DESIGN RECOMMENDATION MEETING

T6 INNOVATION
CENTER

SDCI: 3038240-LU / 3038247-LU

May 3rd, 2023

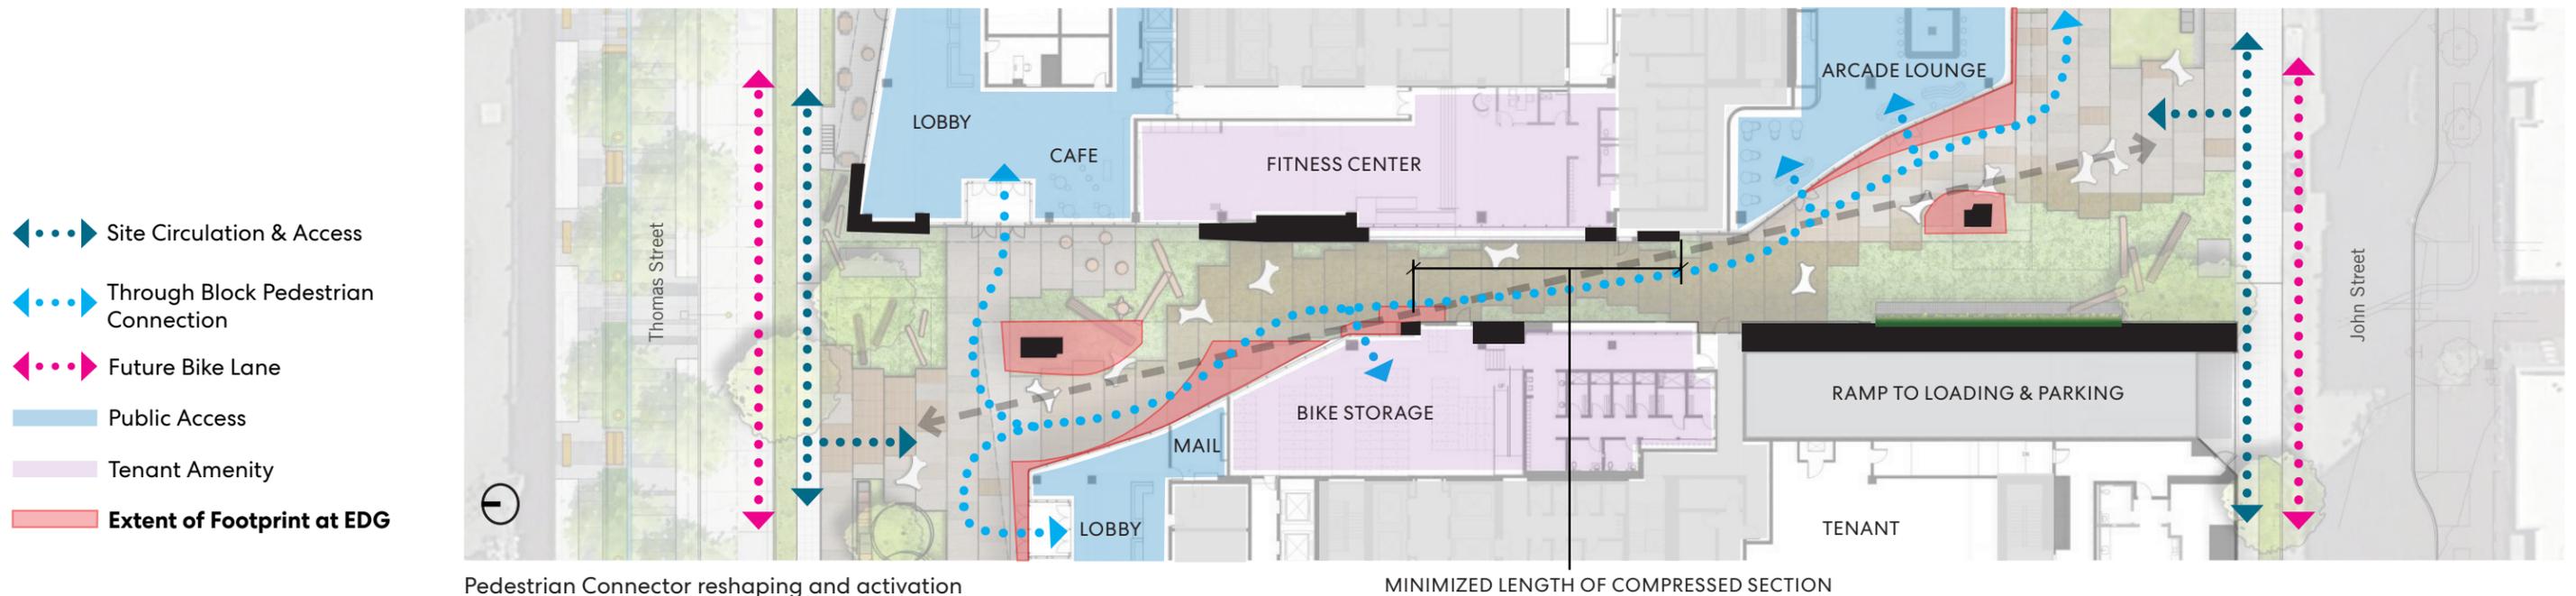
3) The Board supported the schematic thinking behind the pedestrian path between the two structures, but expressed concern regarding how the design of the two structures under review affected its shape, composition, and public appearance, and offered the following guidance:

3a) To invite public use and activation of the vacated alley, **carve away and pull back the building edges at the two entrances** to allow clear views through the site

3b) **Physically and visually strengthen the diagonal route** highlighted by the applicant in the packet and in the presentation.

3d) Design the site and landscape elements to clearly **convey the public nature** of the plazas and path, and to **invite use by members of the public**

3f) Explore programming alley edges with active uses that will **engage the public and create opportunities** for human interaction

3a) Key components that have been modified or strengthened within the public connector are to increase visibility into the vacated alley are:

- added glazing into the bike area and fitness facility
- more public presence to lobbies through coffee and cafe spaces
- pushed back glazing lines at the public facing arcade and western building lobby.
- thinned the corner footprints of the arches

3b Both north and south open plaza spaces will have open edges & d) that are at grade and flush with the surrounding sidewalks, blending seamlessly with the public ROW, inviting usage by the surrounding community.

3f) Key programs that interface with the central pedestrian connection include:

- public coffee/cafe with indoor/outdoor seating
- glazing with views to bike storage/repair and the fitness facility
- public access to the arcade event space with connection to the south plaza
- publicly accessible building entries

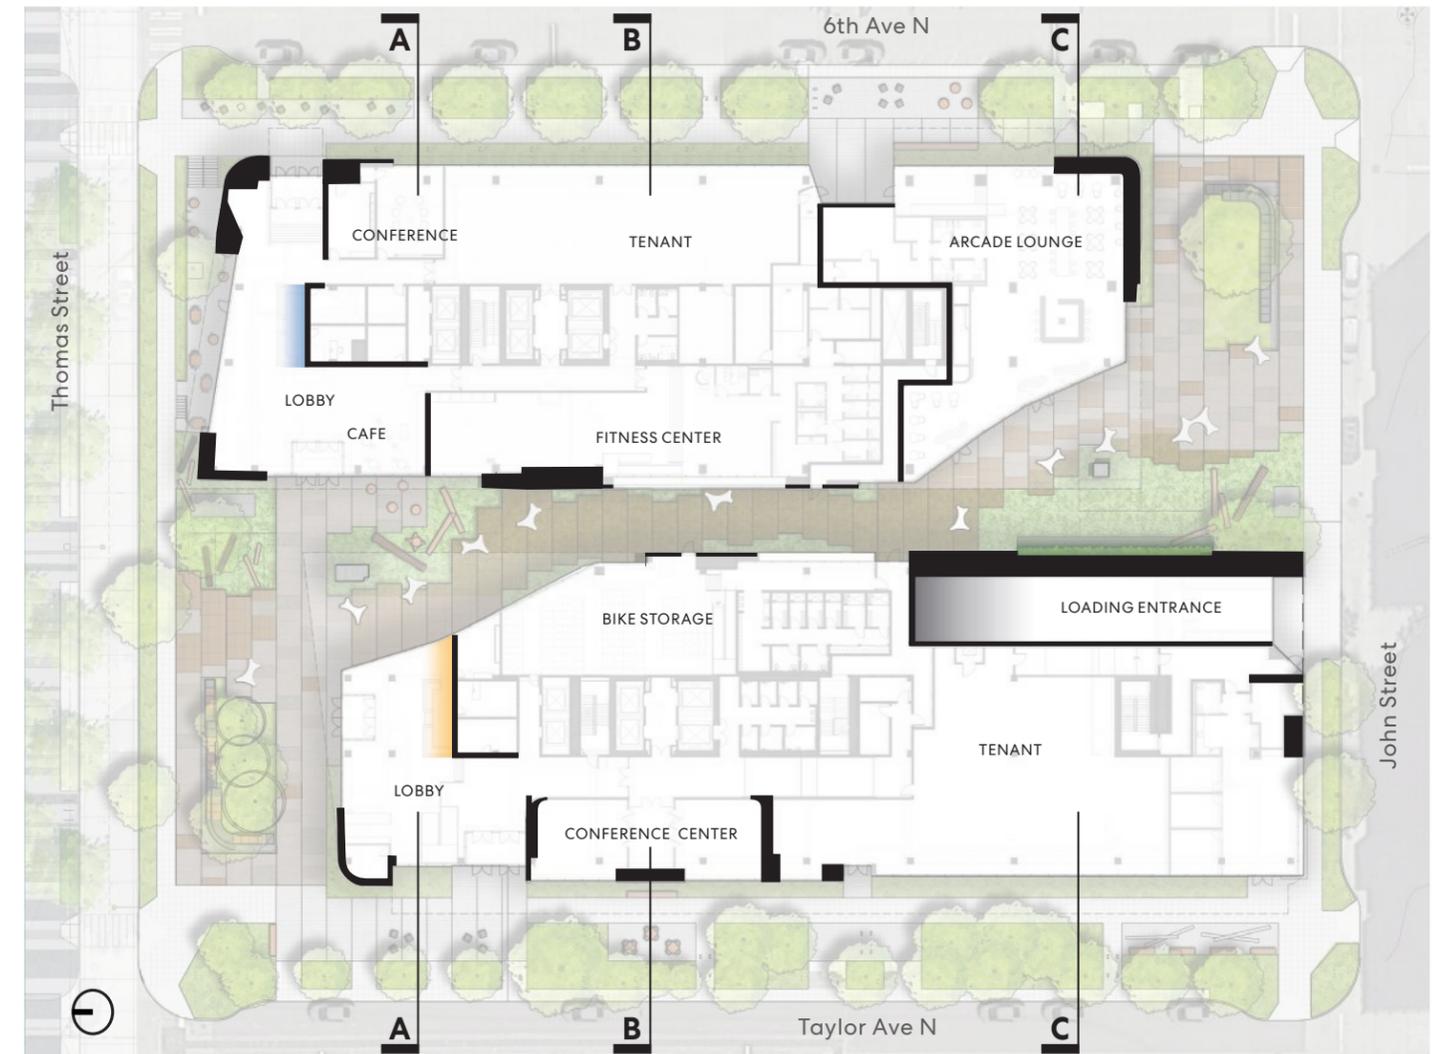
3c) **Reshape and enlarge the space between** the two buildings to allow greater access to light and air and higher visibility from either end of the path

3e) **Reshape and enlarge the opening to the sky** above the alley to provide sufficient light for the proposed landscape elements to thrive and to draw and encourage public use

3c & e) Vacating the alley allows us to remove all back of house and loading activity from the 20-ft width of the alley and move it below grade, creating 4 sides to each building. Taking direction from the Board and the Design Commission to create a more active and public space at the ground plane, the team embraced the narrow space by:

- Added multiple new building entries and active uses in the alley and around the public street;
- creating additional glazing into building amenity spaces helping to expand the visual space;
- pushing and pulling the ground level facade to create spots for sitting and gathering and softened corners;
- plantings have been selected that will thrive and prefer the light levels in the central connector space;
- a mix of low level lighting fixtures and taller pole fixtures will create varying light levels throughout the space, all the while maintaining a very safe environment at all times of day

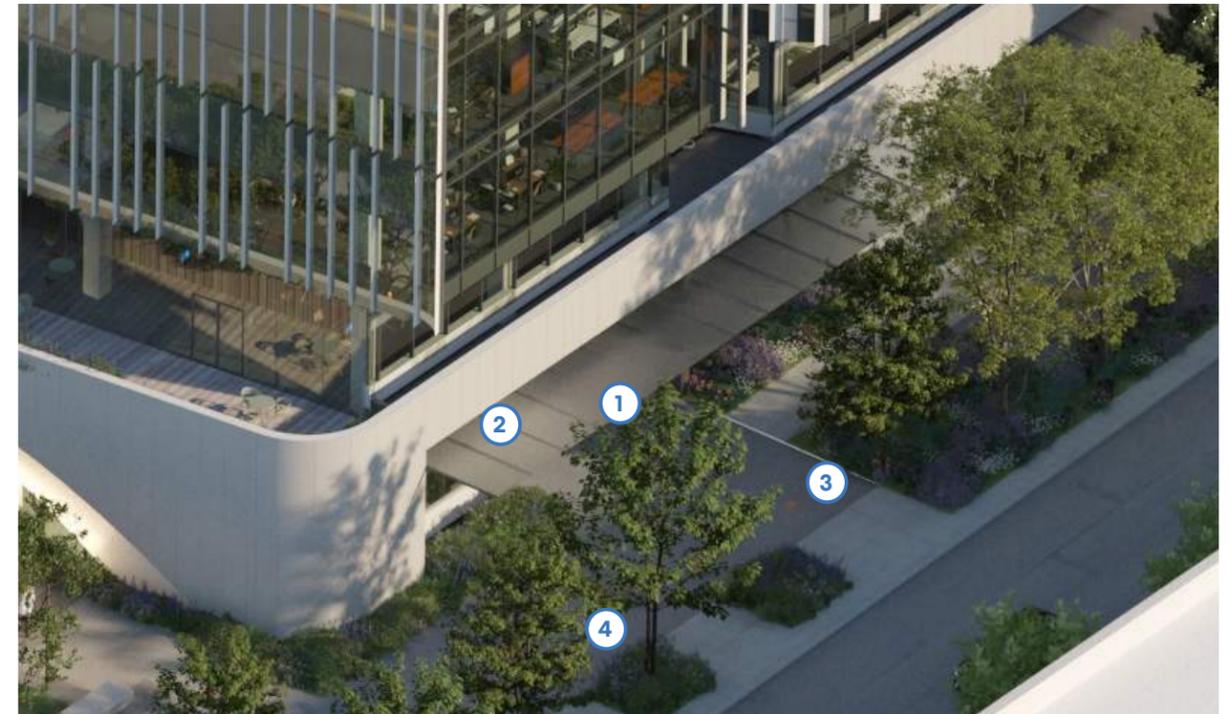
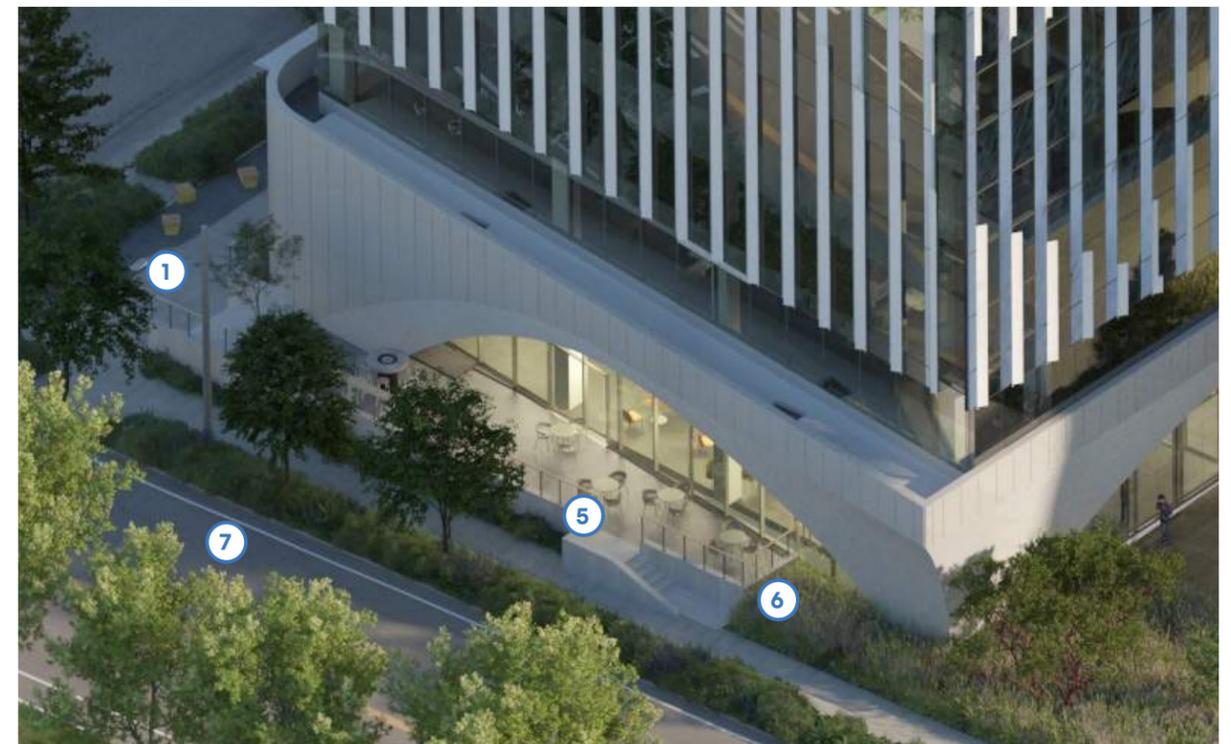
4a) The Board noted the great length of the other two street edges and agreed that these streets **(6th & Taylor Avenues) should receive a similar level of care and attention** in their design. The Board noted that as currently designed they lacked programming elements that would engage the public or spaces offering respite to the pedestrian. The Board provided guidance that they **be developed with active programming, texture, human scale elements, and porosity** to create active and engaging environments

4a) With the proposed change from angled parking stalls to parallel on-street parking the east and west street edges will have substantially increased off-street ROW widths, allowing for large planter strips at a scale that is unique in an urban context, enhancing the pedestrian experience along these edges. Additionally small pocket park amenity gathering spaces have been added along the sidewalks to provide visual interest, places of respite, and expanded walkways through the planting strips to enable connections from the street parking to the sidewalks. The pocket parks are strategically located to correspond to corners, plaza spaces, and newly added building entries along these edges.

- ① Added main entrance (PL3-1)
- ② Extended weather protection (PL2-C)
- ③ Parklet (DC2-D)
- ④ Bike parking (PL4-B)
- ⑤ Connection to street (PL3)
- ⑥ Landscaping buffer
- ⑦ Thomas Green Street

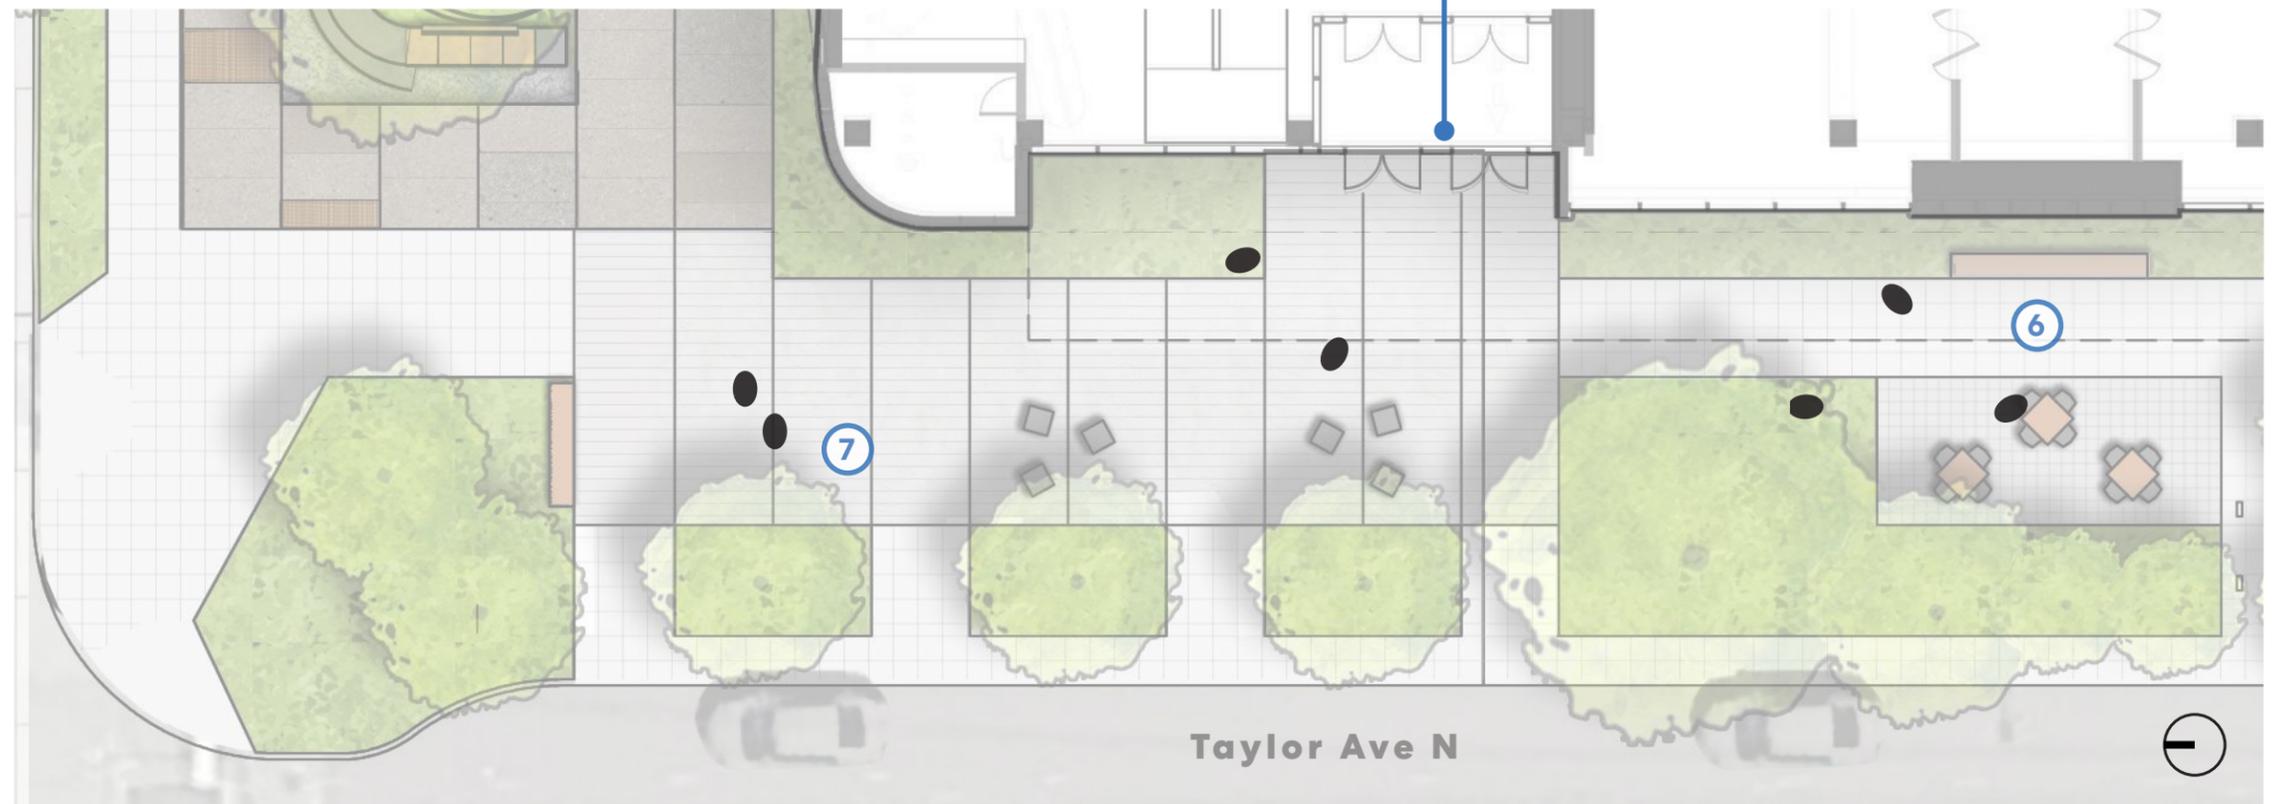
4d) The Board supported the deployment of **gasket** elements on the two longer elevations, both compositionally and to mitigate scale. The Board questioned the articulation and programming of these **elements at the ground plane**, where compositional logic would indicate an important element or area of particular pedestrian interest. The Board agreed that this is a **significant issue given the lack of pedestrian amenity or interest along these edges** and that this disconnect should be resolved in conjunction with the issues identified at 4.b., above

4e) The Board agreed that **overhead weather protection should be well integrated** with the design concept and articulation on the street edges

4f) The Board recognized opportunities to **incorporate public art** and provided guidance to fully explore these, noting this neighborhood's history as a center for the Arts and the guidance provided in the Uptown Neighborhood Guidelines

4d) Landscape programming has been developed along the widened right of way on the longer facades to provide relief for the pedestrian. Pedestrian scale at the longer street facing facades on 6th and Taylor has been incorporated by several elements:

- Stepping the interior floor slab at ground level and providing low knee walls so that the interior activity of the building follows the natural grade of the right of way.
- Additional entries added along the Taylor and 6th Avenues facades have been provided.
- The ground floor base has been modified to hold together as a continuous volume, eliminating the level 1 deep notch on the west (west building), maintaining in at level 2 and above. The east notch on the east building remains at the ground level to give protection to additional entry/exit points. Ground level transparency and opaque surfaces are tuned to reflect program within.

4e) Overhead canopies are incorporated into the façade detail and datums created at Level 01 along Taylor Ave., 6th Ave. and a portion of John St.

4f) Opportunities for art are being developed with the client. Additionally key landscape features are planned for the site including feature trees and nurse log installations.

EDG - West building

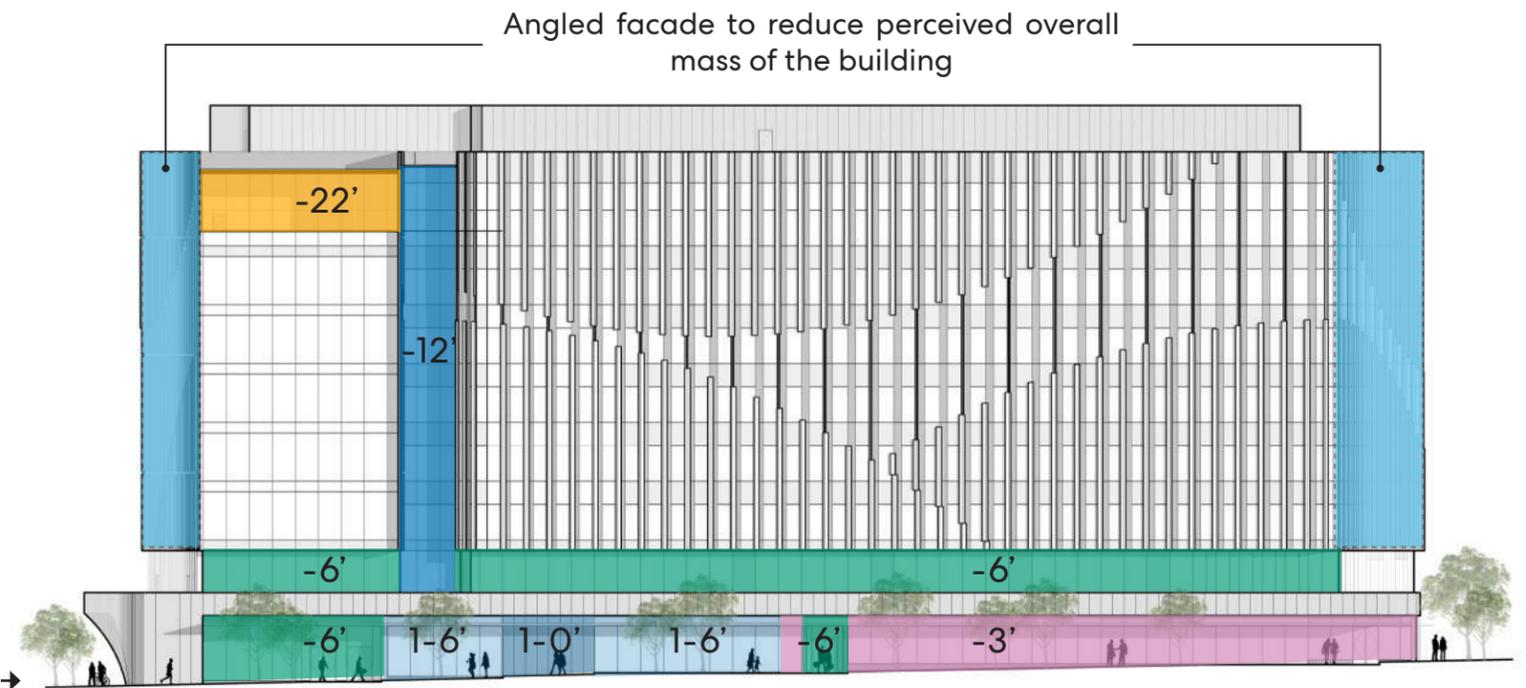
5a) The Board expressed general support for the harmonious composition of elements at the upper levels, noting in particular their contrasting expressions and variations in parapet height and the resulting potential to **help break down scale**. The Board provided guidance to **strengthen both the expression and contrast between these elements** as the design develops

5b) The Board agreed that the **setbacks and offsets** deployed to reinforce the legibility of these elements **should be strengthened**, noting specifically the limited impact of a one-foot offset in a structure of this size

5a The facade massing has developed through careful study of the Pacific & b) Science Center pavilions (see page 64).

The elevation shown here along Taylor Ave. (and similarly on 6th Ave) has addressed setbacks and offsets through:

- additional recessed entry points
- increased amount of overhead protection along the facade
- re-proportioned tower massing
- curtain wall fin modulation to continue arch forms differently (see page 57)

Plan of east building loading dock entry

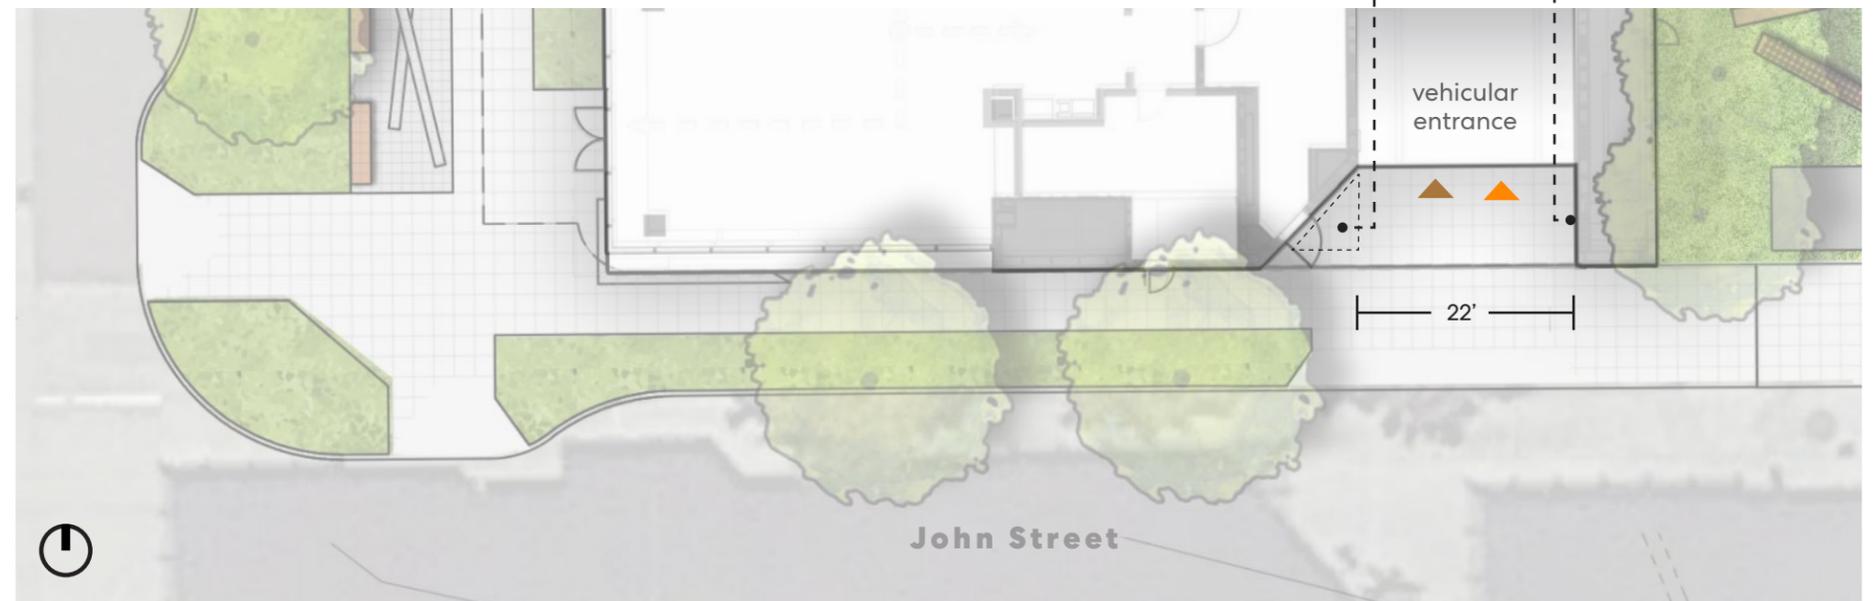
6a) The Board strongly supported a single vehicle access point as it would minimize disruption of the pedestrian realm and provided guidance to **develop a full slate of elements and measures to ensure pedestrian safety**

6b) Echoing public comment, the Board highlighted the importance of bicycle facilities and provided guidance to **include complete infrastructure details** including connections to cycling routes, project entrances, and parking areas

6a) Vacating the alley allows us to pull all loading and back of house below grade instead of in the alley, creating a safer pedestrian environment and removing conflicts onto Thomas Street. The only vehicular access point for passenger and service vehicles is proposed at John Street. The team has continued to develop the safety elements at this access point including required view triangles, signage elements, and mirrors.

6b) Thomas Street has a planned future protected bicycle lane. The project has proposed short term secure bicycle racks along 6th Avenue and Taylor Avenue. Long term bicycle parking to be provided at Level 01, with access from the central pedestrian connection.
